# Mining Action Group

December 8, 2017

We are writing to express our concern that significant changes have taken place with regards to the Aquila Back Forty Mine site. The facility design schematics incorporated in the Back Forty Wetland Permit application (*submitted 11-17-2017*) are radically different from design schematics included in the [Back Forty Mining Permit](#) (*as issued 12-28-2016*). **These changes necessitate reconsideration and amendment under Part 632 of Act 451 of 1994**, which regulates all aspects of nonferrous metallic mining and beneficiation facilities, including siting, construction and environmental impacts:

**Figure 1: Facility Plan, October 2016.** Source: Aquila Back Forty Mine permit application. "Plant site features supplied by Lycopodium in July 2015." Aquila submitted this facility plan with its Mining permit application in November 2015.

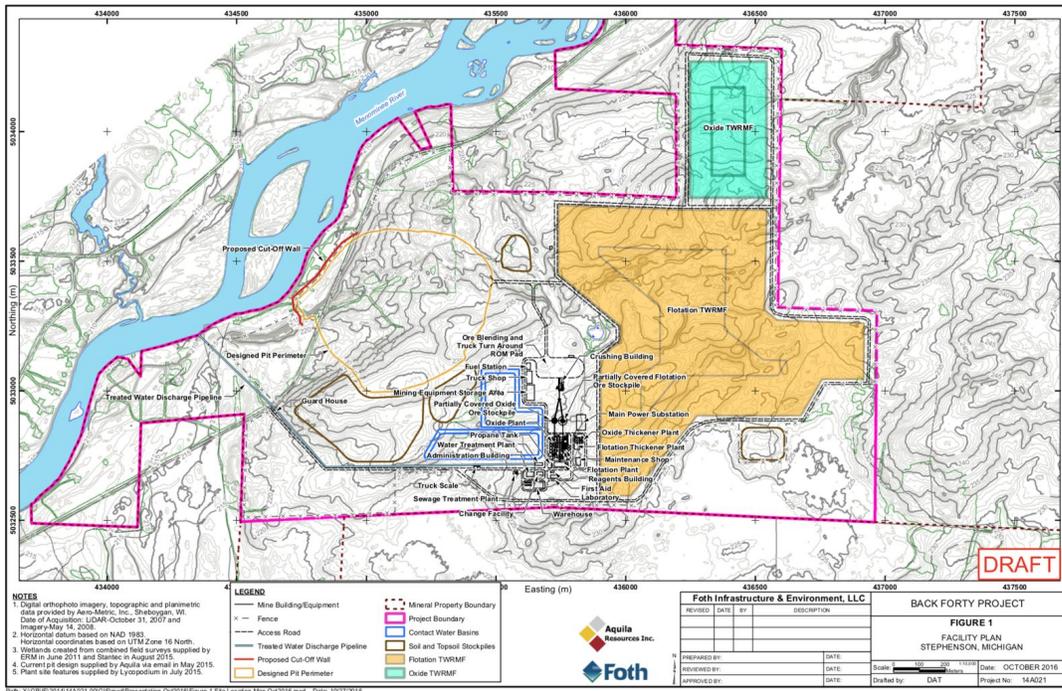
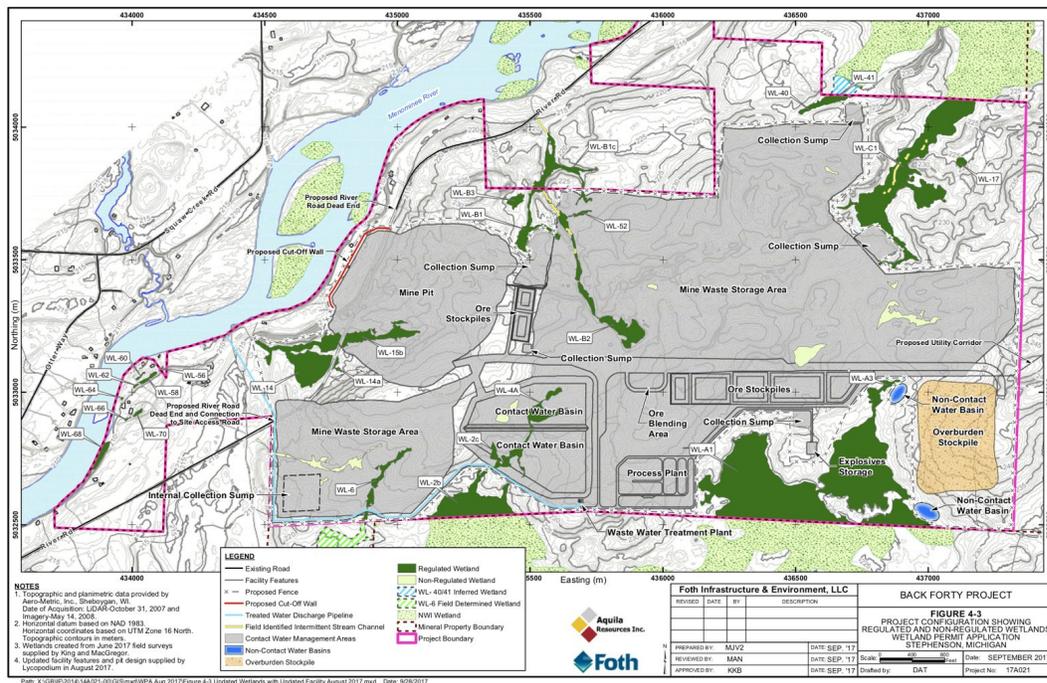
Figures 1 and 2 (attached) show that the Aquila Back Forty mine site has been extensively reorganized. These changes impact critical components of the operation, including but not limited to the mine's project boundary, the affected area, location of haul roads, oxide and flotation mine waste storage areas (TWRMF), sumps and contact water basins, "treatment and containment of earth materials" such as overburden stockpiles and ore stockpiles, beneficiation buildings, pipelines and utility corridors.

These are significant changes. For example, the Tailings and Waste Rock Management Facilities (TWRMF) have been resized and relocated. The apparent changes involve at least one *permanent, impervious TWRMF structure*, which would become a permanent feature of the landscape with long term leachate collection and treatment concerns, with potential impacts on surface water and groundwater.

The new mine site design plan for the Back Forty – illustrated in the Back Forty Wetland permit application ("1 R-Wetland Permit Application Nov 2017 reduced Sections 1-4.pdf" page 40) – is clearly integral to a comprehensive review of the pending Wetland permit application. The revised site design is likely to have significant impacts on surficial hydrology and hazard mitigation, and financial assurances should be reviewed. **We are especially alarmed by the relocation of one TWRMF, to a site roughly 1 mile west of the permitted location. If the new facility schematic is to be believed, Aquila's reactive tailings – one of the most risky aspects of a sulfide mining operation – will now be stored approximately 1,000 feet from the bank of the Menominee River.**

We ask that the DEQ act swiftly, requiring an amendment of the Back 40 mining permit, addressing all "anticipated changes in the mining operation, including, if applicable, amendments to the environmental impact assessment and to the mining, reclamation, and environmental protection plan." We request that the DEQ require this amendment *before considering the company's Wetland permit*, since it is based upon an unpermitted facility design.
